DESCRIPTIVE REPORT

Type of Survey Hydrographic
Field No. FA-10-5-85
Registry No. H-10202

State Alaska
General Locality .. Chatham Strait
Sublocality Point Thatcher to Entrance
..... to Kelp Bay
.....
..... 1985
.....
CHIEF OF PARTY
CAPT J.W. Carpenter

DESCRIPTIVE REPORT
to Accompany Hydrographic Survey
H-10202 (FA-10-5-85)
NOAA Ship FAIRWEATHER S-220
Captain John W. Carpenter, Commanding

CHART
17337
1:40,000

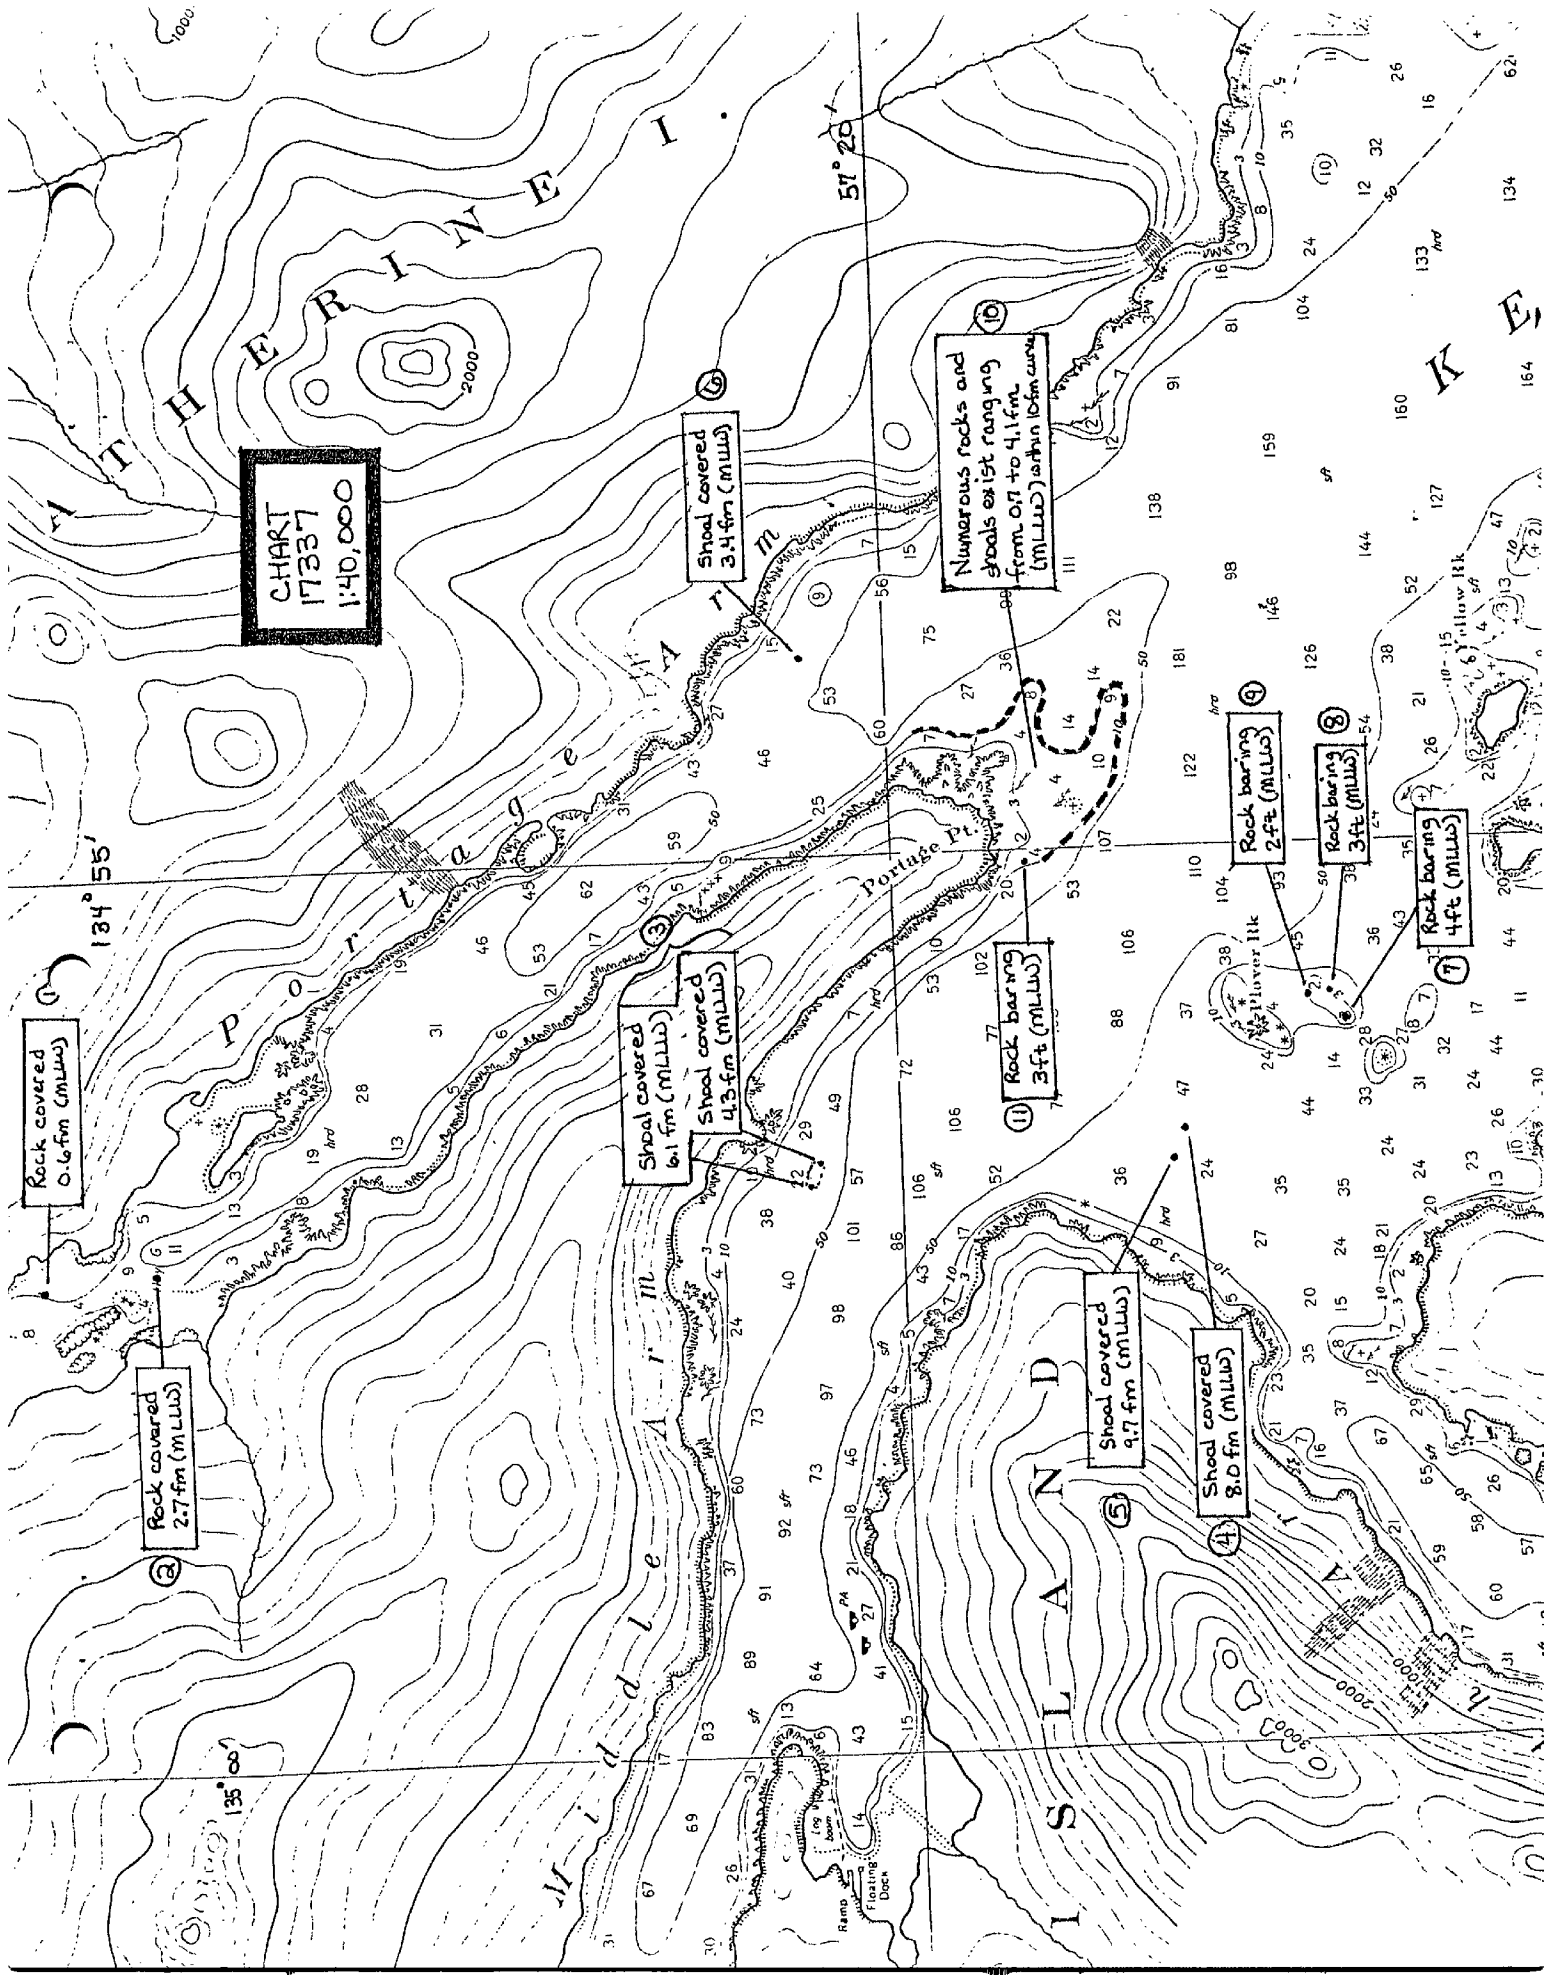
Shoal covered
3.4 fm (mllws)

Rock covered
0.6 fm (mllws)

Shoal covered
6.1 fm (mllws)
Shoal covered
4.3 fm (mllws)

Rock baring
3 ft (mllws)
